# Supporting Material for D2.0 Comments

**IEEE P802.3cw Task Force**  
**IEEE 802.3 Sept 2022 Interim**

# What is the 400GBASE-ZR (Per P802.3cw D2.0)

Figure 155-1—400GBASE-ZR PCS and PMA relationship to the ISO/IEC Open Systems Interconnection (OSI) reference model and the IEEE 802.3 Ethernet model

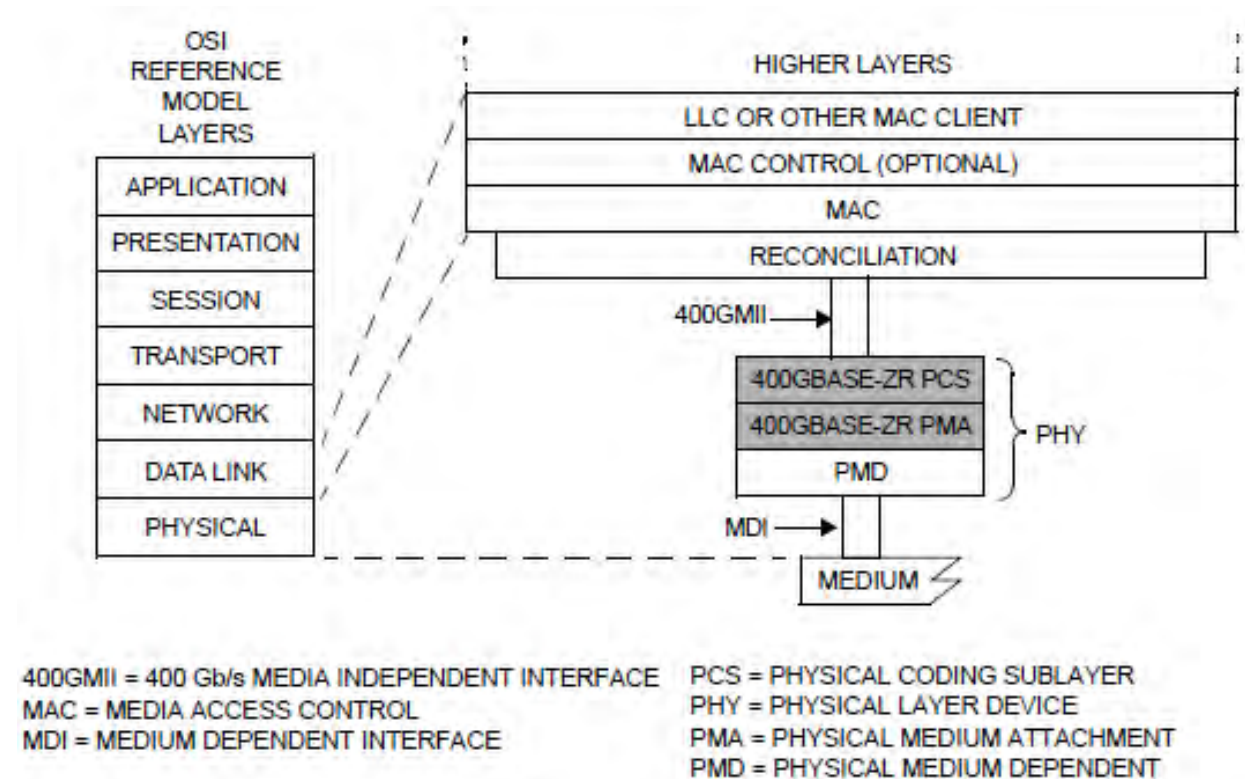
- 400GBASE-Z
  - The term is only used 2x in Draft 2.0 (1. Page 18 1.4.144b and 2. Page 35 155.1.5)
  - There is no family of “Z” devices at 400 GbE – just 400GBASE-ZR

- 400GBASE-R encoding
  - No definition for “400GBASE-R encoding”
  - 1.4.141 400GBASE-R: An IEEE 802.3 family of Physical Layer devices using the physical coding sublayer defined in Clause 119 for 400 Gb/s operation. (See IEEE Std 802.3, Clause 119.)

- Per 116.1.3 - 400GBASE-R represents a family of Physical Layer devices using the Physical Coding Sublayer for 400 Gb/s operation over multiple PCS lanes (see Clause 119). Physical Layer devices listed in Table 116–2 are defined for operation at 400 Gb/s.

- Per 119.1.1 - The terms 200GBASE-R and 400GBASE-R are used when referring generally to Physical Layers using the PCS defined in this clause.
  - 400GBASE-ZR uses PCS defined by Clause 155

- 400GBASE-ZR
  - Not a family
  - Not 400GBASE-R encoded
  - 400GBASE-ZR PCS and PMA encoded (See Clause 155)

1. Delete 1.4.144b (a “family” can be created in future when necessary). Replace 400GBASE-Z with 400GBASE-ZR throughout draft.
  2. Modify 1.4.144c –
    - 400GBASE-ZR: IEEE 802.3 Physical Layer specification for 400 Gb/s dense wavelength division multiplexing (DWDM) PHY using 400GBASE-ZR PCS and PMA encoding, dual polarization 16-state quadrature amplitude (DP-16QAM) modulation, and coherent detection with reach up to at least 80 km. (See IEEE Std 802.3, Clause 155 and Clause 156.)

3. Modify description Table 116-2
    - 400 Gb/s PHY using 400GBASE-ZR PCS and PMA encoding capable of transmission over a specified channel on a defined DWDM grid in each direction of transmission with reach up to at least 80 km (see Clauses 155 and 156)

4. Modify 155.1.1
    - Delete current text and replace with
      - This clause specifies the physical coding sublayer (PCS) and physical medium attachment (PMA) sublayer for the physical layer implementation known as 400GBASE-ZR. The 400GBASE-ZR PCS and 400GBASEZR PMA are sublayers of the 400GBASE-ZR PHY listed in Table 116–2. The term 400GBASE-ZR is used when referring to the 400GBASE-ZR PHY, which uses the PCS and PMA defined in this clause.

Figure 120A-9—Example 400GBASE-ZR PCS/PMA layering with two 400GMII and 400GAUI-8 interfaces

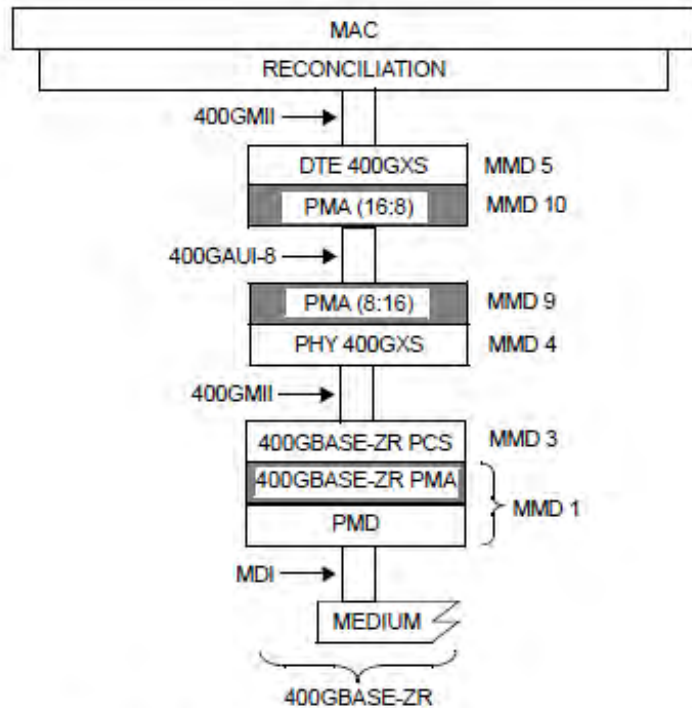
- **Does not use the 400GBASE-R PCS (Clause 119)**
- **400GMII Extender can only exist above any PHY (Refer Fig 118-1)**
  - Uses 400GBASE-R PMA (Clause 120) as defined by Clause 118

- Can use 400GAUI-16 C2C (Annex 120B) as defined by Clause 118
  - Can use 400GAUI-16 C2M (Annex 120C) as defined by Clause 118
  - Can use 400GAUI-8 C2C (Annex 120D) as defined by Clause 118

- Can use 400GAUI-8 C2M (Annex 120E) as defined by Clause 118
  - Can use 400GAUI-4 C2C (Annex 120F) as defined by Clause 118
  - Can use 400GAUI-4 C2M (Annex 120G) as defined by Clause 118

- **Proposed Remedies**
  1. For the 400GBASE-ZR row in Table 116-5 delete “o” (optional) in following clauses (119, 120, 120B – 120G)
  2. Create two tables in 118.1 Overview (see Page 10)

3. Update Table 156-1 (See Page 11)
  4. **Create paragraph in 156.1 explaining use of 400GMII Extender for supporting optional physical instantiation of an AUI.**
